## NEW MEXICO OIL CONSERVATION DIVISION

**APPLICATION FOR AUTHORIZATION TO INJECT**

WELL NAME &amp; NUMBER: Ojo Encino 31Federal-SWD 1

Ojo Encino 31 Federal-SWD 1 Application

**Ojo Encino 31 Federal-SWD 1 Schematic Diagram**

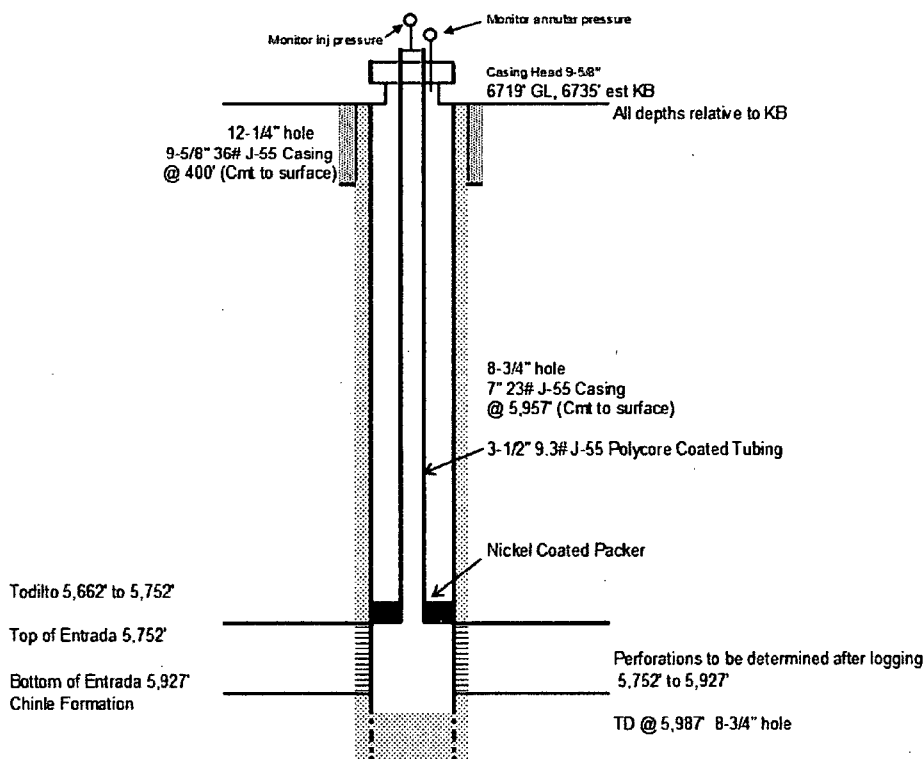
What sort of logging program do you have planned?

Let me know of any pending changes in the planned spud location.

"The logging suite will consist of a Triple-combo log; Gamma Ray-Formation Density Log-Compensated Neutron Log-Spontaneous Potential-Array Induction Log. The Array Induction Log will be run over the open hole from +/- 400¢ to TD. The porosity log will be run over the logging contractor's minimum footage requirement and any potential injection intervals."

The location of the proposed well has not changed, but if it does, I will let you know as soon as possible.
